Contract Number 009516	Contract Title Bagley and Siebert Creeks – Remove Fish Barriers	Federal Aid Number NHPP-0101(361)
Change Order Number 010	Change Description CDSM Deletion	Date August 12, 2020
Region Olympic Region	Project Engineer Dan McKernan	Phone Number 360-565-0620
Prime Contractor / Design-Builder Scarsella Bros.

CONTRACT NO: 009516 FEDERAL AID NO: NHPP-0101(361)  
CONTRACT TITLE: BAGLEY AND SIEBERT CREEKS-REMOVE FISH BARRIERS  
CHANGE ORDER NO: 10 CDSM DELETION

**SOIL STABILIZATION SHAFT PANEL PLAN**  
NOT TO SCALE

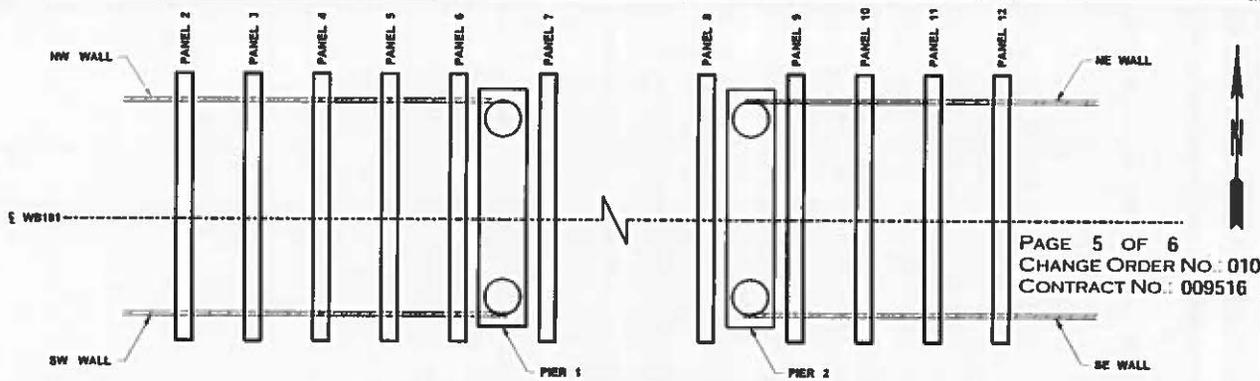
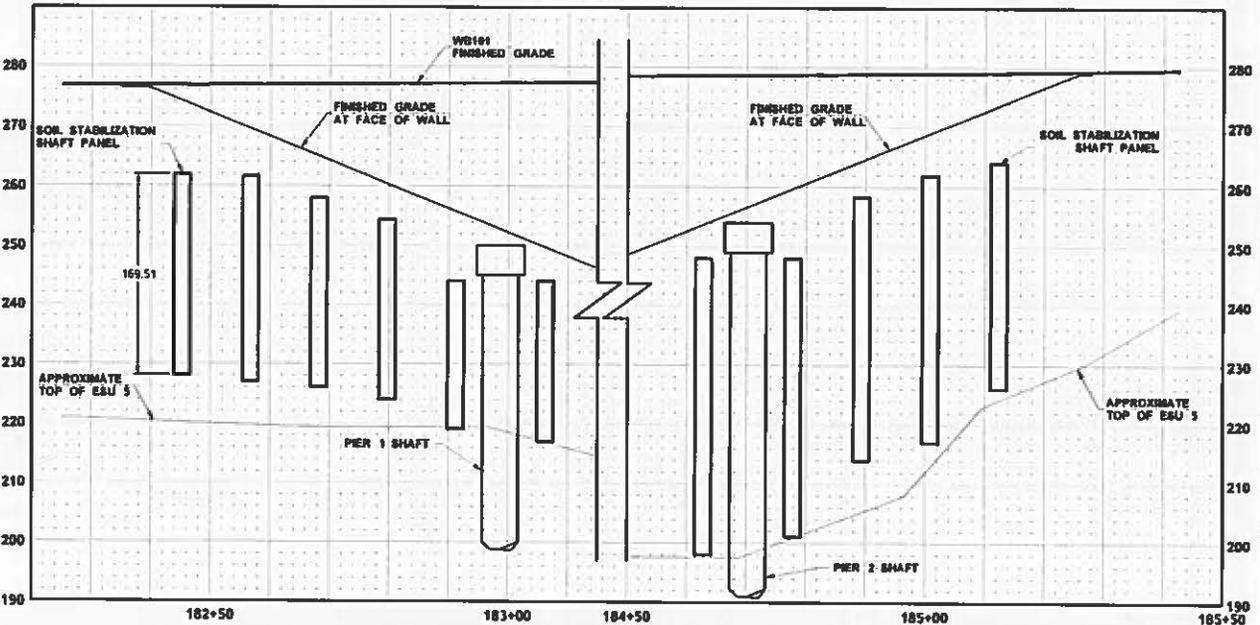
The Contractor shall install 4.9 foot diameter Soil Stabilization Shafts in lieu of the specified Cement Deep Soil Mixing (CDSM). Soil Stabilization Shafts shall be installed per the details on pages 5 and 6 of this change order.

- Cleanout of the bottom of the Soil Stabilization Shafts as specified in Section 6-19.3(3)D will not be required.
- The equipment and procedure for installation of Soil Stabilization Shafts shall be able to penetrate through the previously installed CDSM Panel 13 and deal with the expected cobbles and boulders. If encountered, shaft obstructions as defined in Section 6-19.3(3)E will be addressed under the new item "Removing Soil Stabilization Shaft Obstruction." The equipment and procedure shall also be able to penetrate through adjacent soil Stabilization Shafts to achieve the required overlap detailed on page 5 of this change order.

"Soil Stabilization Shaft" will be measured by the linear foot. The linear foot measurement will be calculated using the top of shaft elevation and the bottom of shaft elevation for each shaft as defined on page 5 and 6 of this change order.

- SEE STANDARD SPECIFICATIONS 6-19 AND CHANGE ORDER TEXT FOR CONSTRUCTION REQUIREMENTS.
- BOTTOM ELEVATION OF SHAFTS A, F AND K SHALL BE AS SHOWN ON THE SOIL STABILIZATION SHAFT PANEL SCHEDULE UNLESS TOP OF ESU-5 IS HIGHER.
- APPROXIMATE ELEVATION IS SHOWN. BOTTOM OF ALL SHAFTS SHALL EXTEND TO THE TOP OF ESU-5.
- SEE SHEET 517-S FOR REQUIRED DEPTHS OF SHAFTS @ C, D, E, G, H, I AND J FOR PANELS 2, 3, 4, 5, 10, 11 AND 12.
- SOIL STABILIZATION PANEL TOP ELEVATION SHALL MEET REQUIREMENTS FOR DIMENSIONS SHOWN ON SHEET 512-S.
